## **DAWSON POINT SUBDIVISION, FIRST ADDITION**

APPLICATION NUMBER 7 DATE April 20, 2006  
APPLICANT Dawson Point Subdivision, First Addition  
REQUEST Subdivision

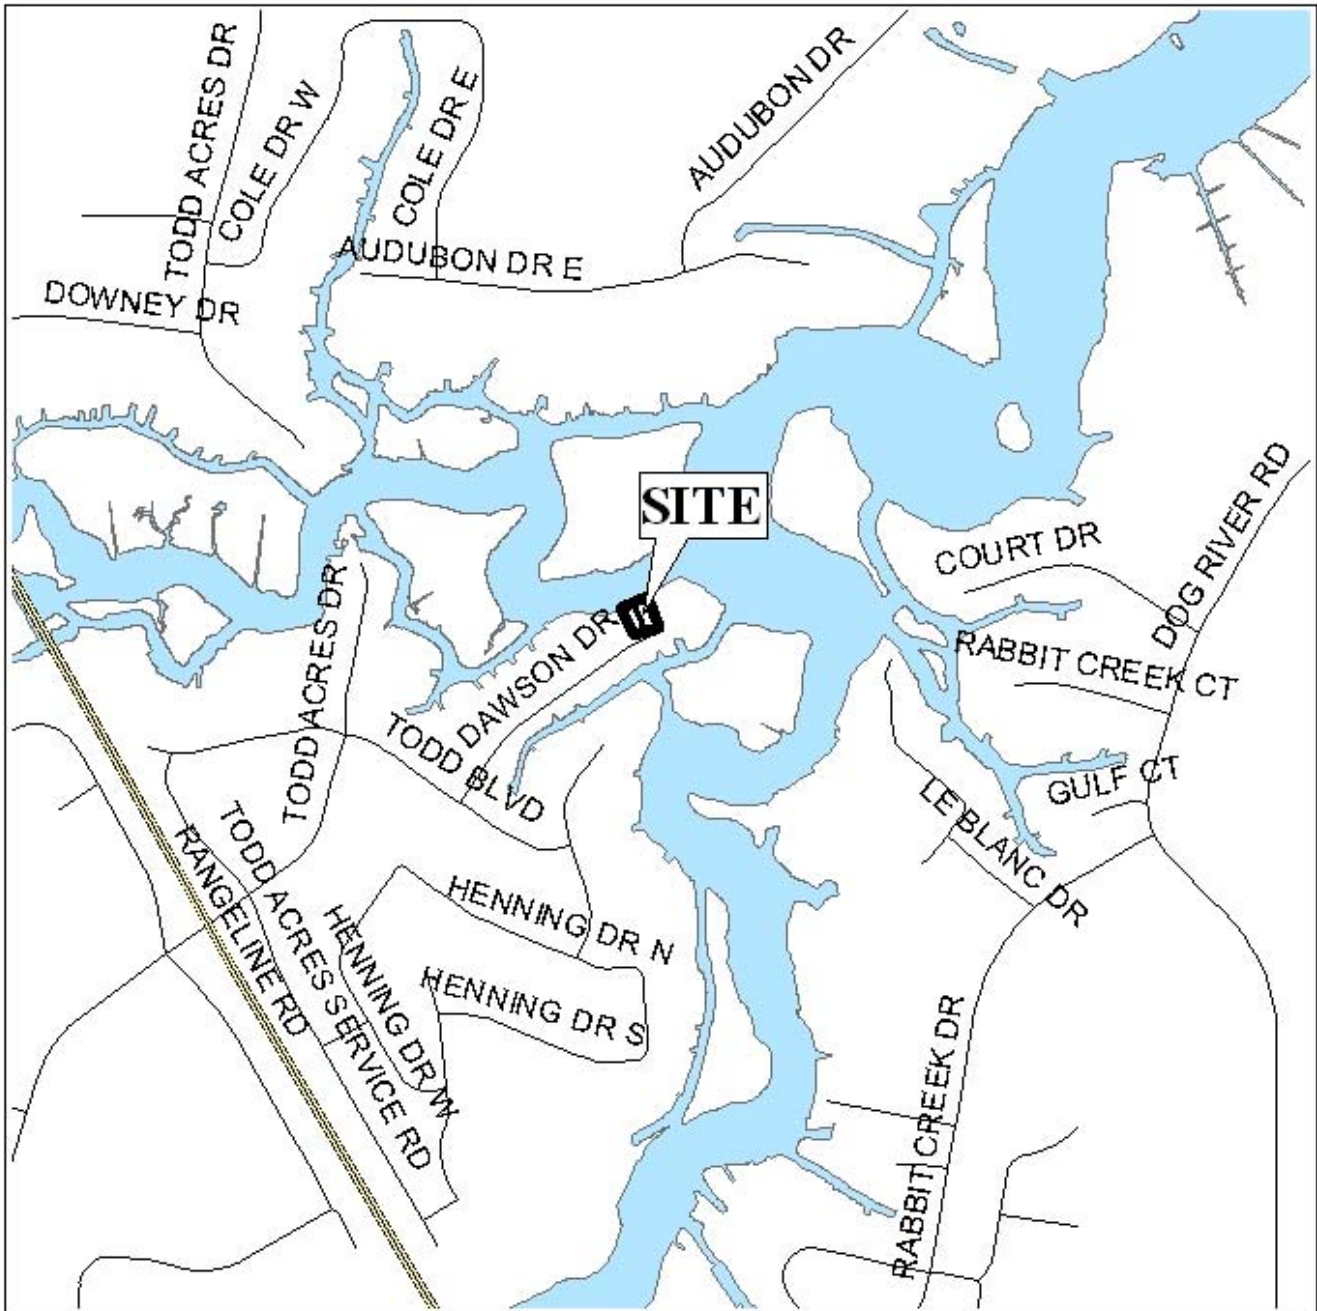
The plat illustrates the proposed 0.4 acre  $\pm$ , 2 lot subdivision which is located on the North side of Dawson Drive at its East terminus, and is in Council District 4. The subdivision is served by both public water and sanitary sewer.

The site fronts onto Dawson Drive, a minor street with a right-of-way of 50 feet. Dawson Drive lacks curb and gutter, and according to Section V.B.14. of the Subdivision Regulations should have a right-of-way of 60 feet. Therefore, the plat should be revised to depict dedication of sufficient right-of-way to provide 30 feet as measured from the centerline of Dawson Drive.

The existing lot has 92.7  $\pm$  feet of frontage, and as proposed, will be divided into two lots with approximately 46.3  $\pm$  feet of frontage each. The proposed lots at their widest point will only be 62.5  $\pm$  feet wide, along Rattlesnake Bayou. Each proposed lot will exceed the minimum area dimension of 7,200 square feet, but will not achieve the minimum 60-foot width required by Section V.D.2. for over 75%  $\pm$  of the site. Other lots in the general vicinity appear to have road frontages of least 60 feet, with the exception of pie-shaped lots proposed for the cul-de-sac adjacent to the site in question. As proposed, the subdivision will create lots that are not in character with the general vicinity.

Access management is a concern due to the limited width of each proposed lot. It is recommended that each lot be limited to one curb-cut each onto Dawson Drive, with the size, design and location to be approved by the Traffic Engineering and conform to AASHTO standards.

Based on the preceding, the plat is recommended for Denial for the following reasons: 1) the proposed lots are not in character with surrounding development, per Section V.D.1. of the Subdivision Regulations; and 2) the proposed lots do not provide sufficient buildable area meeting the minimum width requirement of Section V.D.2. of the Subdivision Regulations.
